TECHNICAL SERVICE BULLETIN

75-C-2

Austin MG

FRONT NUMBER PLATE MOUNTING
POSITION

Fig. 1

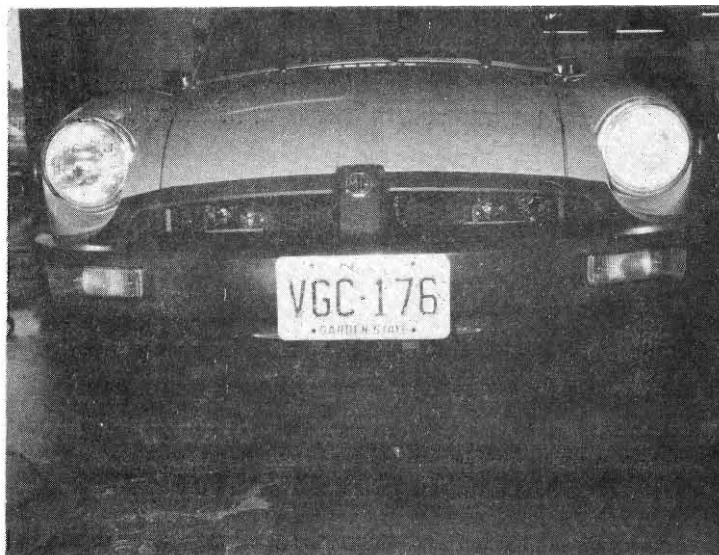
In order to facilitate better cooling at highway speeds, it is recommended that two small holes are drilled in the front bumper and the number plate relocated and attached by self-tapping screws. (See Fig. 1) The existing number plate brackets and plinth can be discarded.
